# City of Surrey PLANNING & DEVELOPMENT REPORT Application No.: 7923-0282-00

Planning Report Date: December 2, 2024

- OCP Amendment to allow for a higher density in the Town Centre designation
- TCP Amendment to allow for a density of 5.68 FAR within the High Rise Mixed-Use designation
- Rezoning from C-35 to CD (based on RM-135 and C-8)
- Development Permit

to permit the development of a 30-storey mixed-use building consisting of 445 dwelling units and 1,024 square metres of at-grade commercial space in Guildford.

LEVEL 7 LAYOUT PLAN

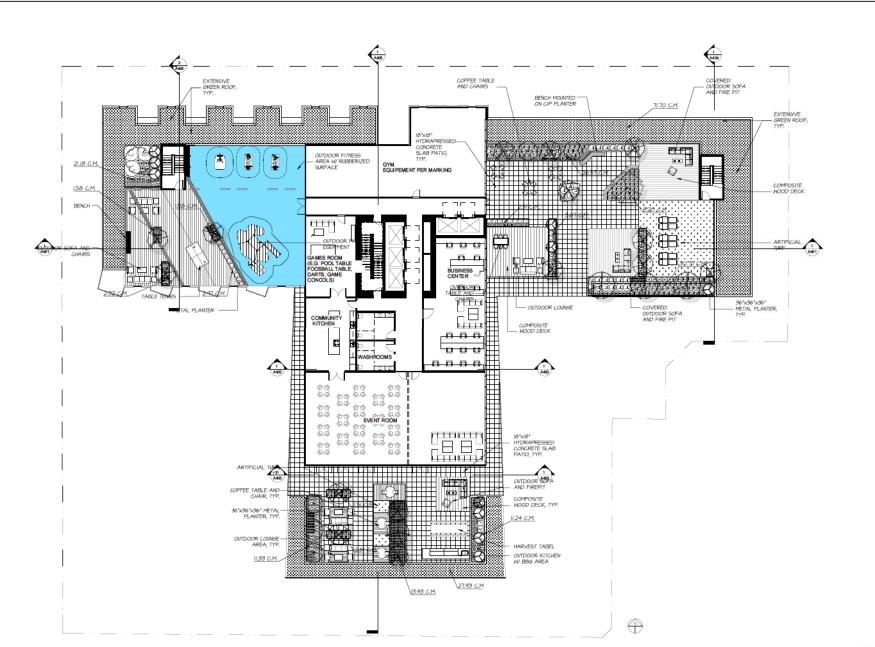
• Consider additional planting on the level seven childcare area.

Response: Shade structures and trellis have been added to level 7 to provide shade.

Response: Additional planting has been added to level 7.

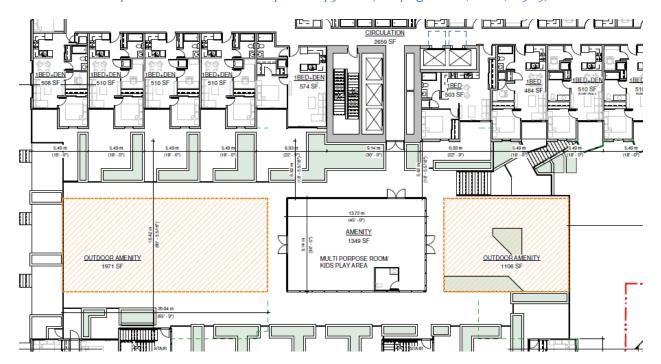
Consider the impact of the east zero-lot line concrete wall on adjacent site.
 Consider providing visual interest on the large expanse of exposed wall on the northeast corner of the property by introducing variation in finish colour and/or texture.

The east podium is setback after the 4th floor. Of the 4 floors on zero lot line, only levels 2-4 will actually be exposed from the street, due to the neighbouring existing building at the zero lot line. The exposed concrete mimics the striped pattern of the main facade. (see page A302, A902, A903)

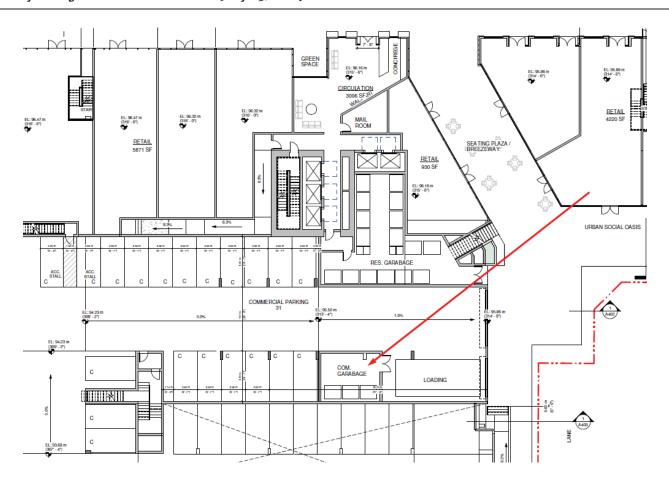
• Consider adding covered area on the level seven amenity area.

• Consider increasing the ventilation for windowless bedrooms.

\*Increased covered area on the level seven amenity.

All windowless bedrooms were removed in favour of dens.

Note: Dens have no closets and sizes limited to prevent den used as bedrooms. (see floor plans. pages  $A_{222}$ - $A_{230}$ )
